P5023A-03B-S

# Safety Service Note

## P5023A Keysight Streamline USB Vector Network Analyzer

“POTENTIAL BURN INJURY (HIGH TEMPERATURE) HAZARD”

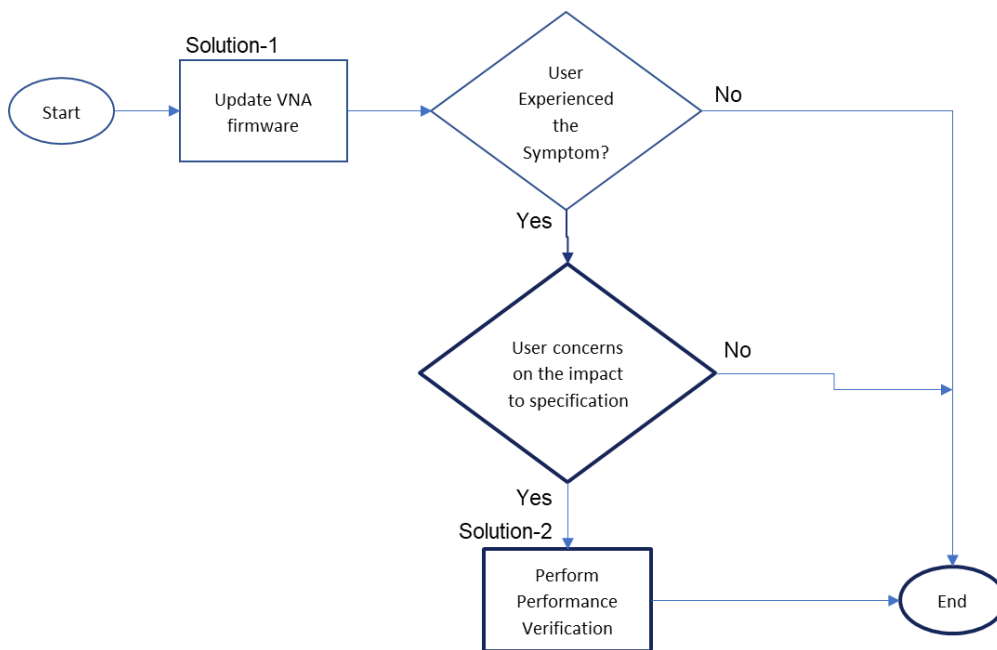
VNA fails to start with the following symptoms.

- 1. LED indicator (below circle) turns red.
- 2. cooling fan does not work
- 3. If user leaves the VNA with this LED indicator red without turning off power switch, it continues to overheat and becomes too hot.

Solution-1: Update VNA firmware by user

Solution-2: Perform Performance Verification by Keysight

1. **Install the latest VNA firmware Rev. A.15.40.13 or newer** on users' controller PC(s).  
The latest firmware enhanced the thermal fan control mechanism.
2. Once the latest firmware is installed, proceed with the restart of both **controller PC** and **VNA**.
3. Launch the VNA firmware. Ensure VNA powers up and launches into firmware correctly after firmware update is done.
